From: Wayne Jones <wayne@wjonesarchitecture.com>
Sent: Wednesday, August 22, 2018 2:14 PM
To: RentalHelp
Subject: Comments on draft of 2019 QAP

FIG. 1003.12.1.1
MINIMUM KITCHEN CLEARANCE IN TYPE A UNITS

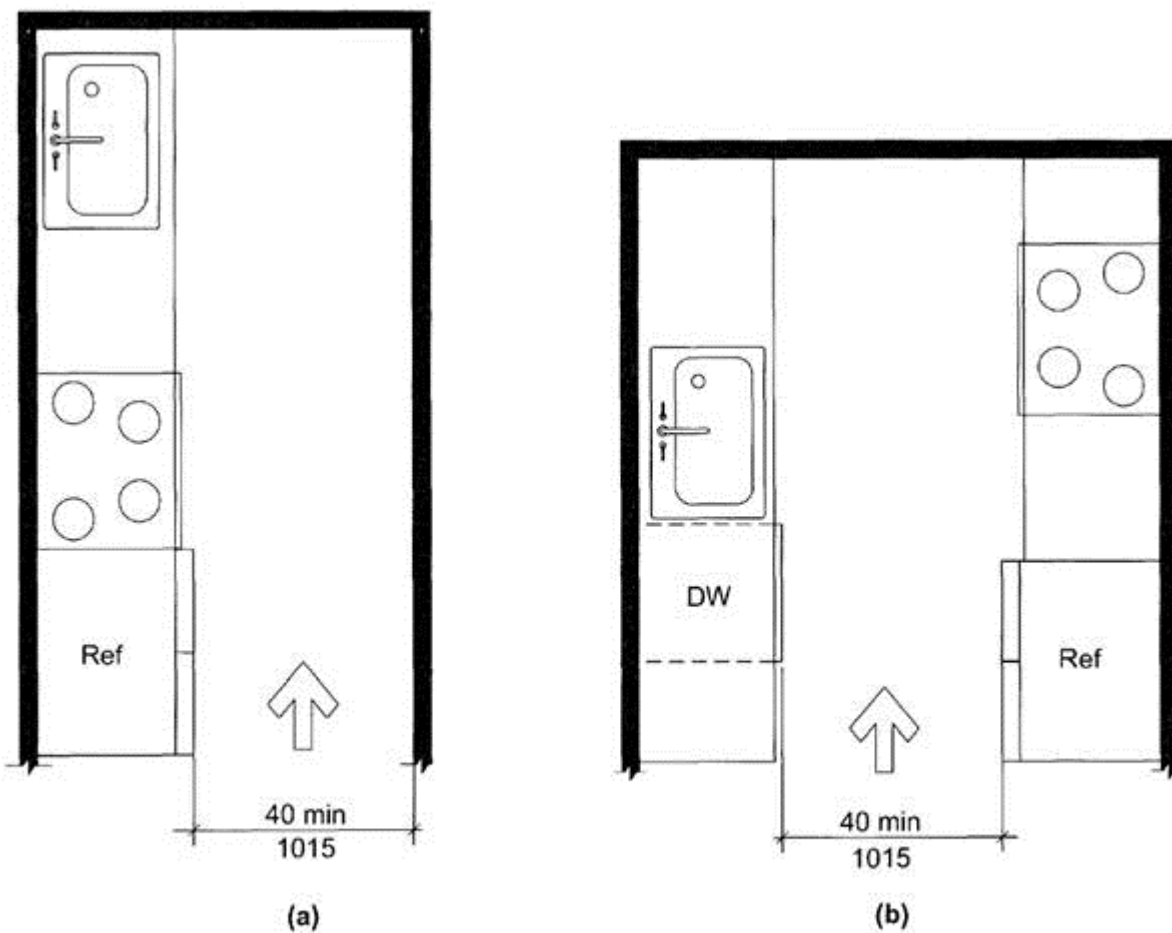
II.C.20 re: 60 inch minimum turning radius in Type A kitchens, my understanding is that this requirement (... in all usable areas of the kitchen...) is in excess of ANSI requirements based on illustrations in ANSI for a galley Type A kitchen. If the intent is for the NCHFA standard to exceed the ANSI standard, it may be useful to state that.

**FIG. 308.2.1
UNOBSTRUCTED FORWARD REACH**

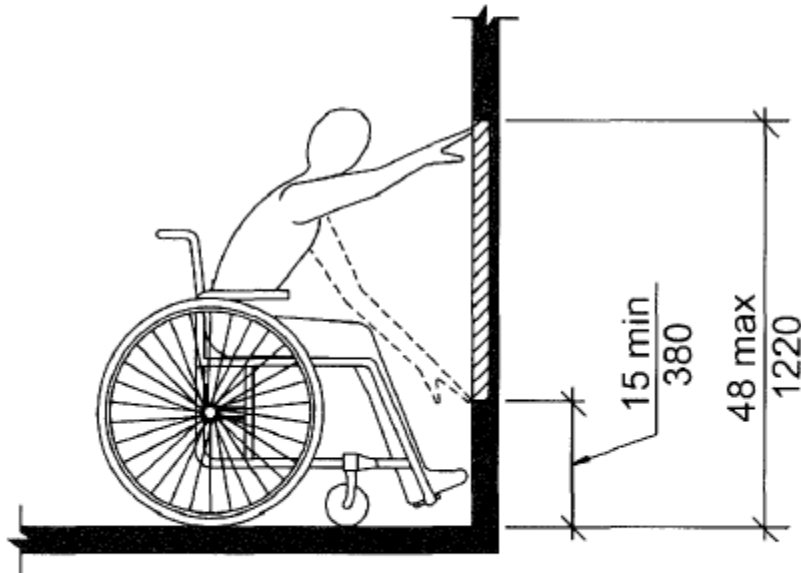
V.C.4. “Mailboxes may not be installed higher than 48 inches above finished floor and must be centered with a 48-inch clear floor space for a parallel approach.”. The parallel approach component of this requirement appears to be in excess of the forward reach requirement that would appear to apply, allowing a 30” space centered on the mailbox. If the intent is for the NCHFA standard to exceed the ANSI standard, it may be useful to state that.

Also, it may be useful to consider the language of 2017 ANSI A117.1 allowing an unobstructed side reach range of 54” for Type B units. However, in my opinion the lack of control over who assigns mailboxes is in conflict with the 54” range, given that a Type A unit may end up with a mailbox over 48”. My point is that with the exception of the 2017 Type B language, I don’t find anything not allowing a forward reach to apply. My intent will be to certainly keep all mailboxes within 48”, I just think a forward reach is allowed.
